Access Compliance Report Public Rights-of-Way (Pedestrian Signals)

Main Street: **NEWLAND_ST** Cross Street: **BOLSA_AVE** Location: **NE**

ADA ID: **SGRK210929131901** Signal Type: **One Push Button-Non APS** Overall Compliance: **No** Severity Scores: **BTN 1: 35** **BTN 2: N/A** **No BTN: N/A**

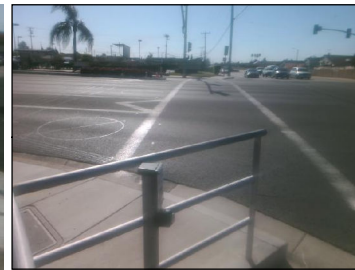
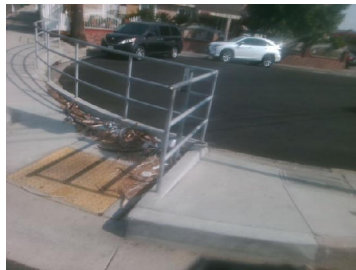
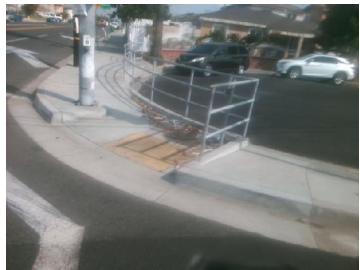
OC Std/PROW: , R404.2, R404.3, MUTCD 4e.08

Possible Solutions: Replace Signal Push Button With APS Button. Remove & Relocate Sign.
